## 10.4 Other Features of Steam and Power Conversion

The information in this section of the reference ABWR DCD, including all subsections, tables, and figures is incorporated by reference with the following departures and supplements.

Figure 10.4-1 Main Condenser Evacuation System

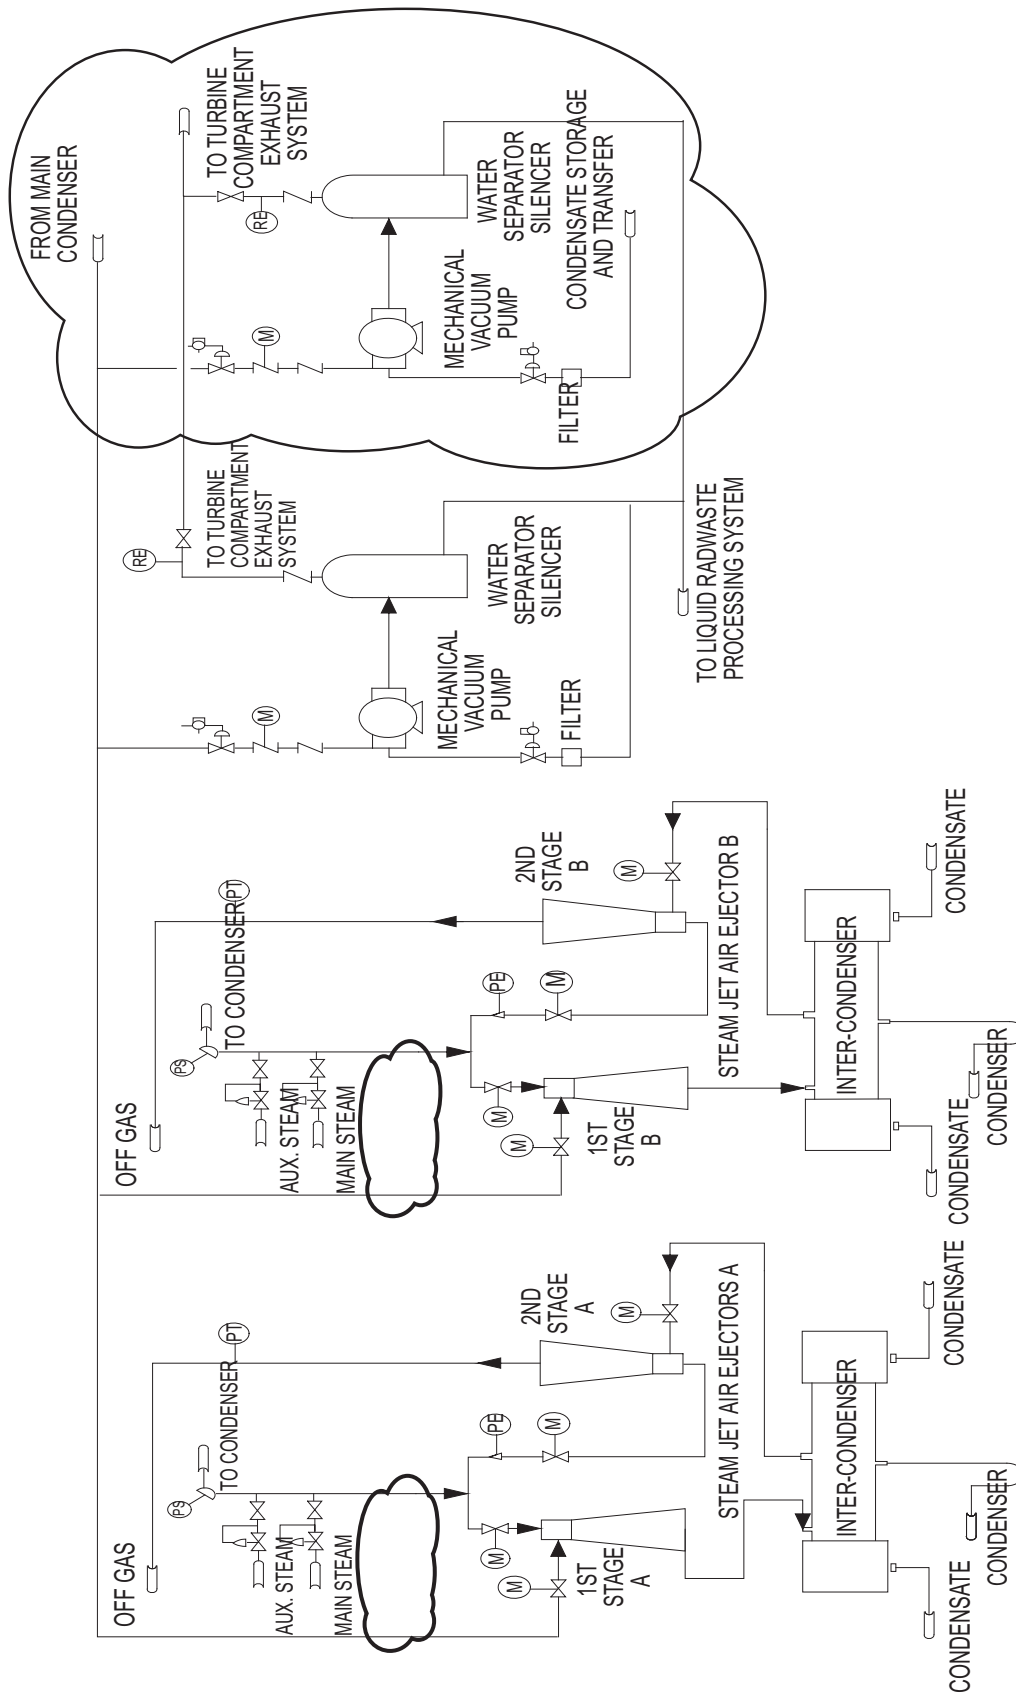
STP DEP 10.4-3 (Table 10.4-2, Figure 10.4-1)

*The MCES (figure 10.4-1) consists of two 100%-capacity, double stage, steam jet air ejector (SJAE) units (complete with ~~intercondenser~~ intercondensers) for power plant operation, and ~~a two, 100% mechanical vacuum pump pumps~~ for use during startup. The last stage of the SJAE is a noncondensing stage. One SJAE unit is normally in operation and the other is on standby.*

*During normal power operations, the SJAEs are ~~normally~~ driven by ~~crossaround steam~~, with the main steam ~~supply on automatic standby~~. The main steam supply, however, is normally used during startup and low load operation, and auxiliary ~~Auxiliary~~ steam is available for normal use of the SJAEs during early startup, should the mechanical vacuum ~~pump pumps~~ prove to be unavailable.*

Figure 10.4-2 Turbine Gland Seal System

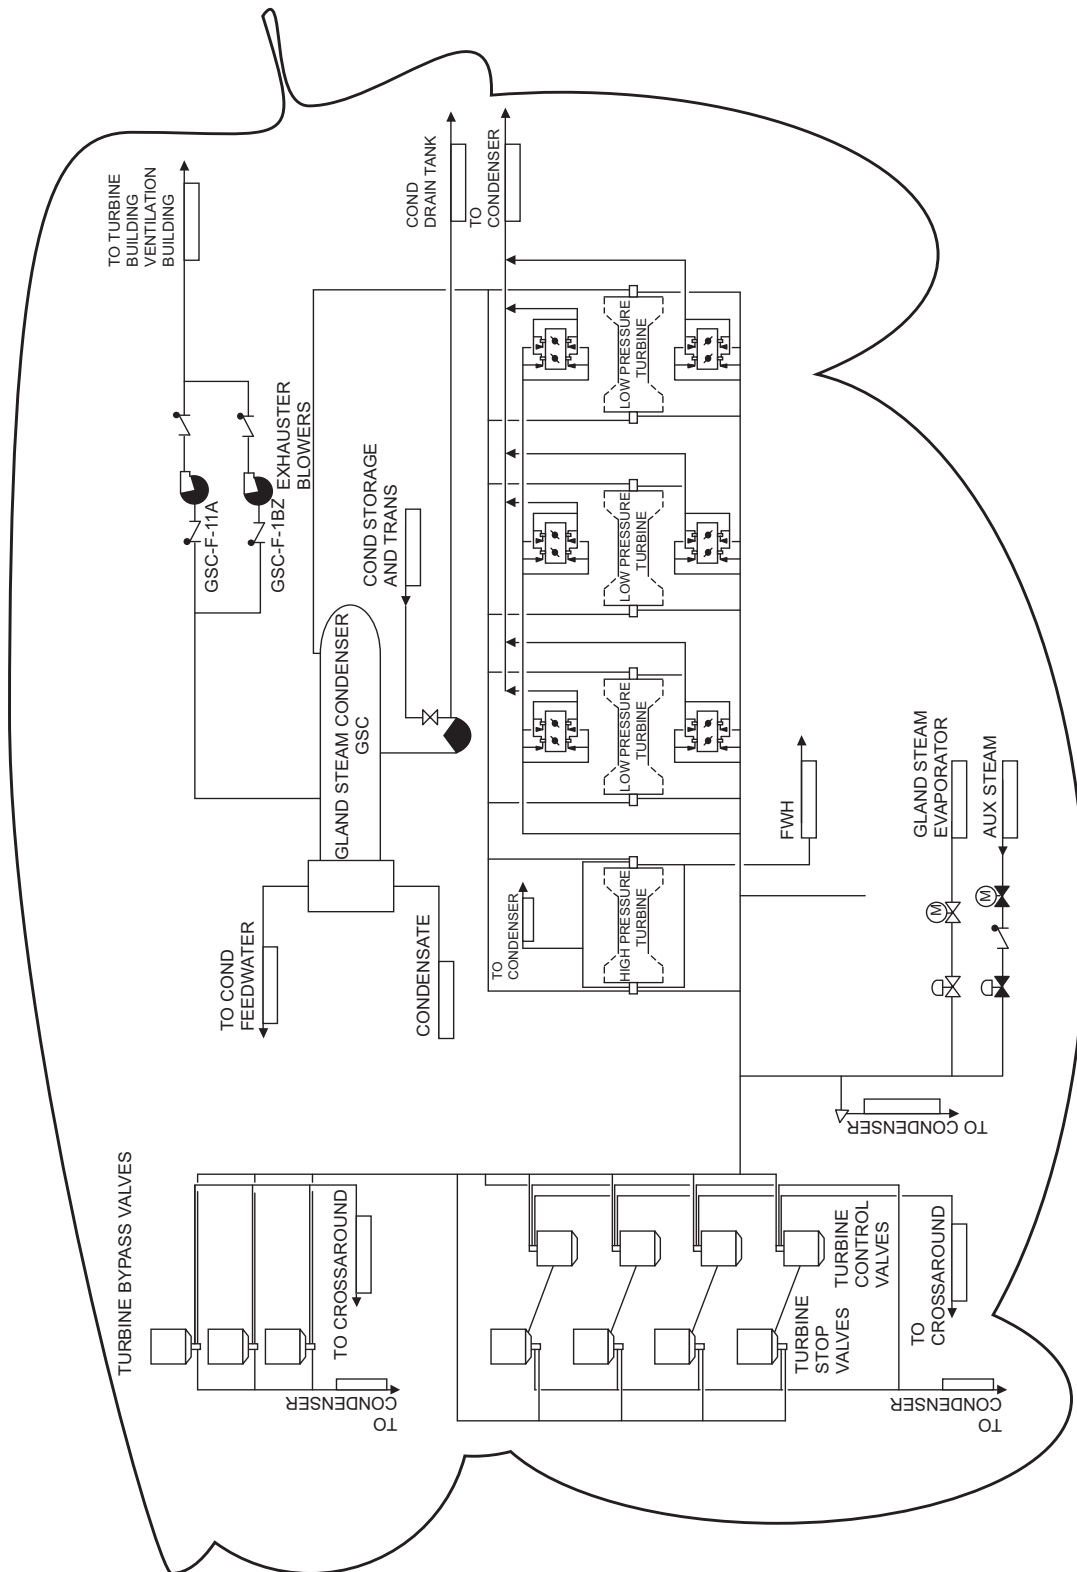
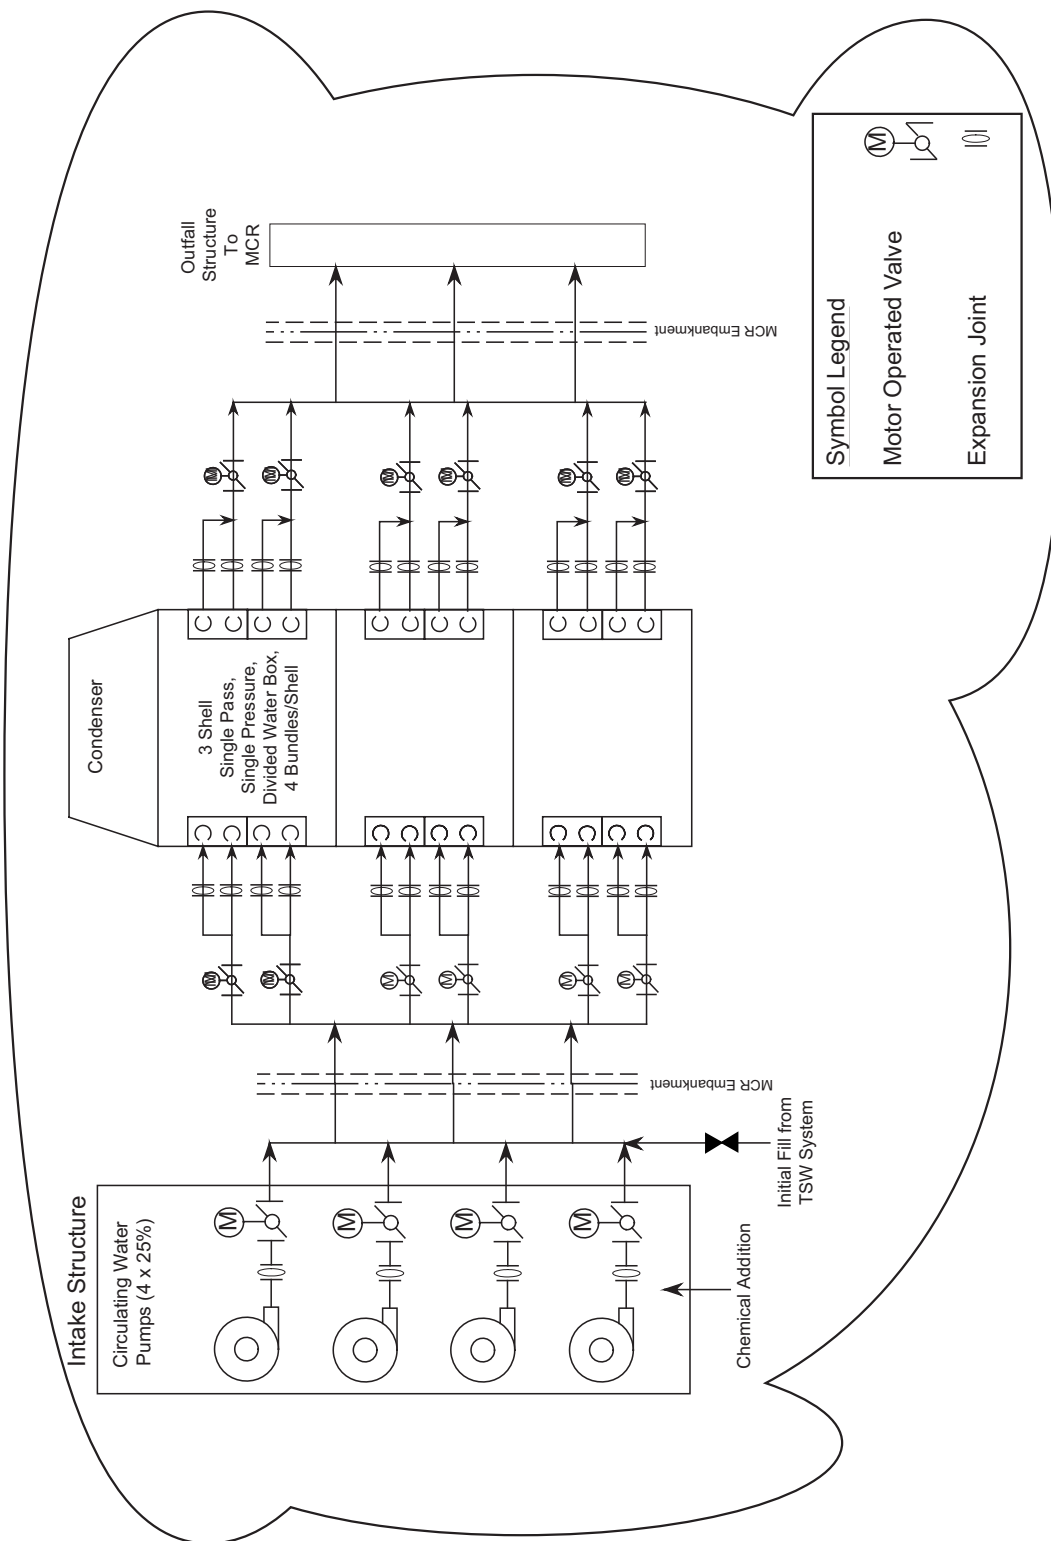
STD DEP 10.4-1 (Figure 10.4-2)

*The turbine gland seal system is illustrated in Figure 10.4-2. The turbine gland seal system consists of a gland steam evaporator, sealing steam pressure regulator, sealing steam header, a gland steam condenser with two full-capacity exhausters blowers, and the associated piping, valves and instrumentation.*

Figure 10.4-4 Condensate Purification System

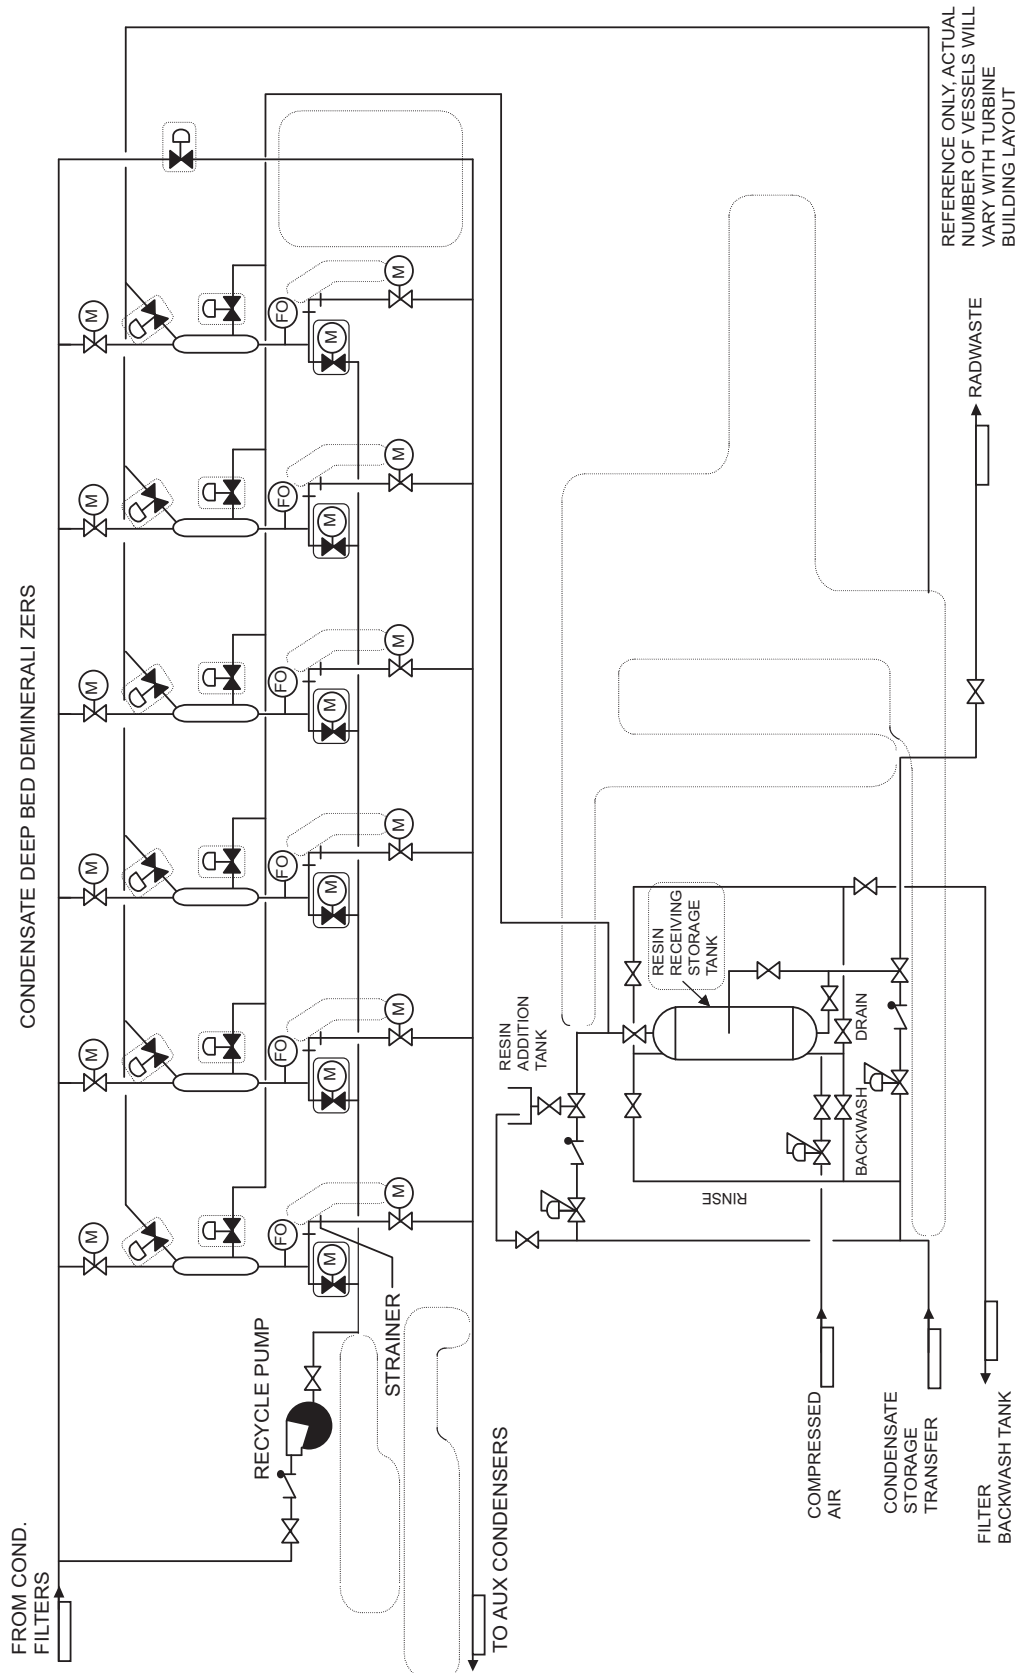
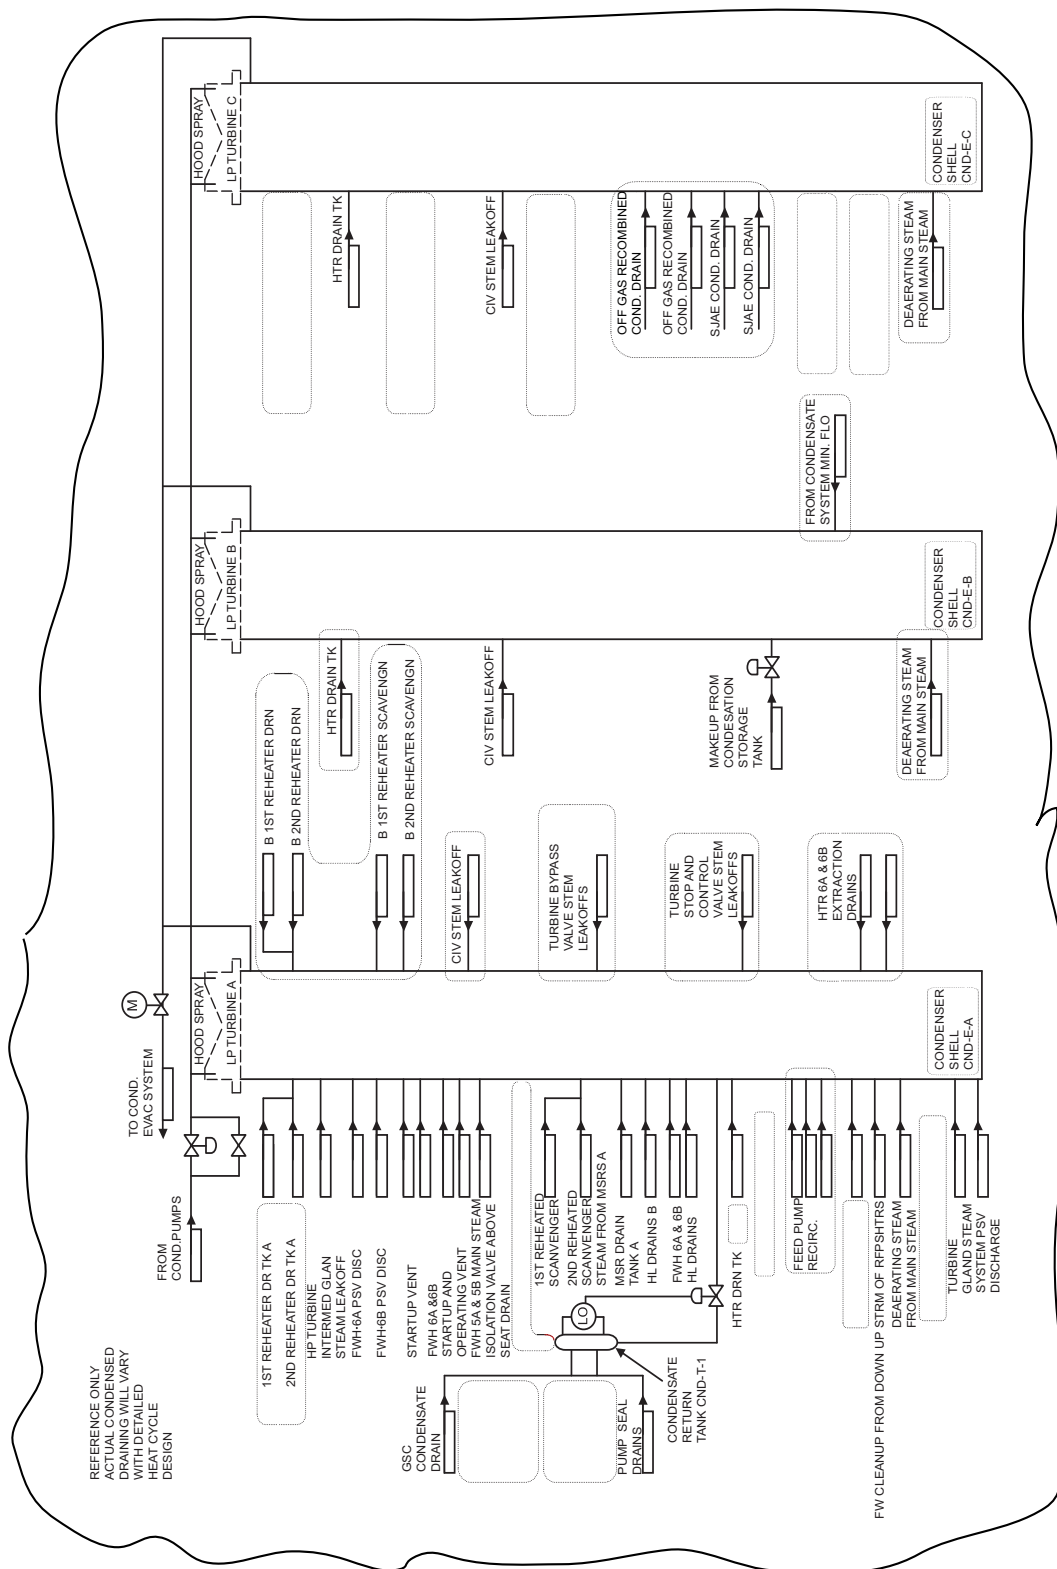
STP DEP 10.4-4 (Table 10.4-4, Figure 10.4-4)

*The Condensate Purification System (Figure 10.4-4) consists of at least three high efficiency filters arranged in parallel and operated in conjunction with a normally closed filter bypass. The CPS also includes at least six bead resin, mixed bed ion exchange demineralizer vessels arranged in parallel with all six normally ~~at least five~~ in operation ~~and one in standby~~. A strainer is installed downstream of each demineralizer vessel to preclude gross resin leakage into the power cycle in case of vessel underdrain failure, and to catch resin fine leakage as much as possible. The design basis for the CPS system will be to achieve the water quality effluent conditions defined in a water quality specification. The CPS components are located in the Turbine Building.*
